**STATE SIGNIFICANT DEVELOPMENT:
Section 96(1A) Modification Application**

**SICEEP, DARLING SQUARE, SOUTH EAST PLOT,
SYDNEY**

SSD 6633 MOD 1

Environmental Assessment Report
Section 96(1A) of the *Environmental Planning
and Assessment Act 1979*

Figure 4: Proposed retail areas 13A and 13B (shaded light blue). Source: Applicant's Architectural Design Report

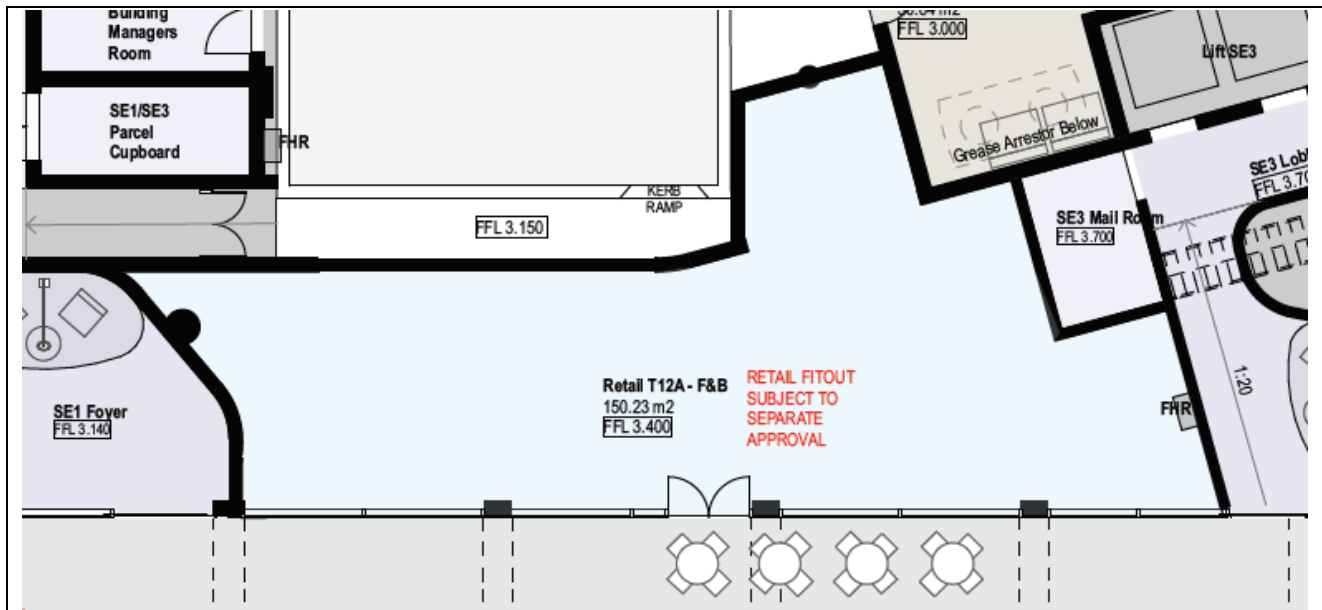
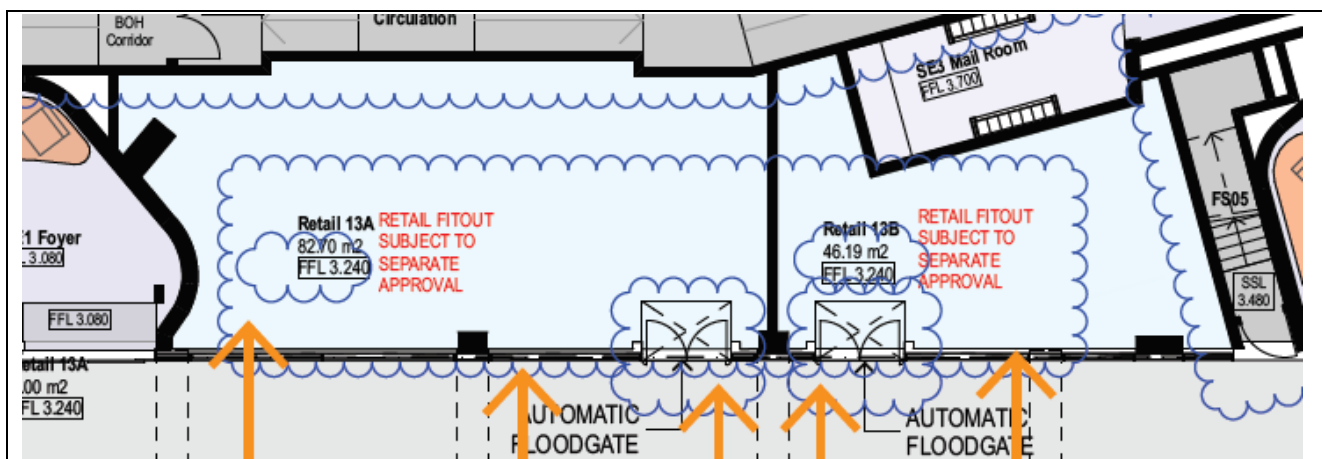
The proposal seeks to divide one retail unit (12A) into two smaller retail tenancies and provide one additional opening fronting Hay Street (13A and 13B) (**Figures 3 and 4**). The Department considers this will improve the activation of the Hay Street colonnade, which was a principal consideration in the assessment of the Stage 1 Concept Plan and SSD approval. In particular, it will minimise the

extent of blank wall, increase the retail mix of the development and create a more diverse, stimulating and attractive street. This design change will also increase shopfront design flexibility to suit a more diverse range of future retail tenants.

Figure 7: Typical example of openings on levels 6 to 29 to be windows with privacy glass (bubbled in blue). Source: Applicant's Architectural Design Report

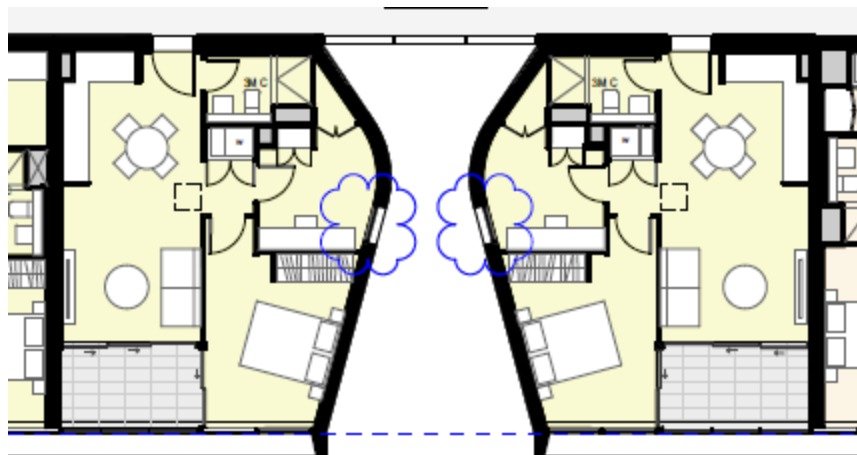
From levels 6 to 29 (above the Podium) the approved aluminium louvres (privacy screens) to study room windows on the southern elevation are proposed to be replaced with windows with privacy glass (**Figure 7**). The Applicant has advised that these windows are to be awning type with maximum 125mm wide opening.

These changes do not give rise to concern about the loss of privacy between units. The Department considers that the inclusion of privacy glass will improve the amenity for future occupants in terms of better daylight access and outlook. The proposed change will not be perceptible from the public

domain and would have no material impact on the overall design quality of the building.

The Department also notes that these windows will need to be designed to meet the Building Code of Australia (BCA) in terms of fire safety to the satisfaction of the certifier in accordance with Condition C5.
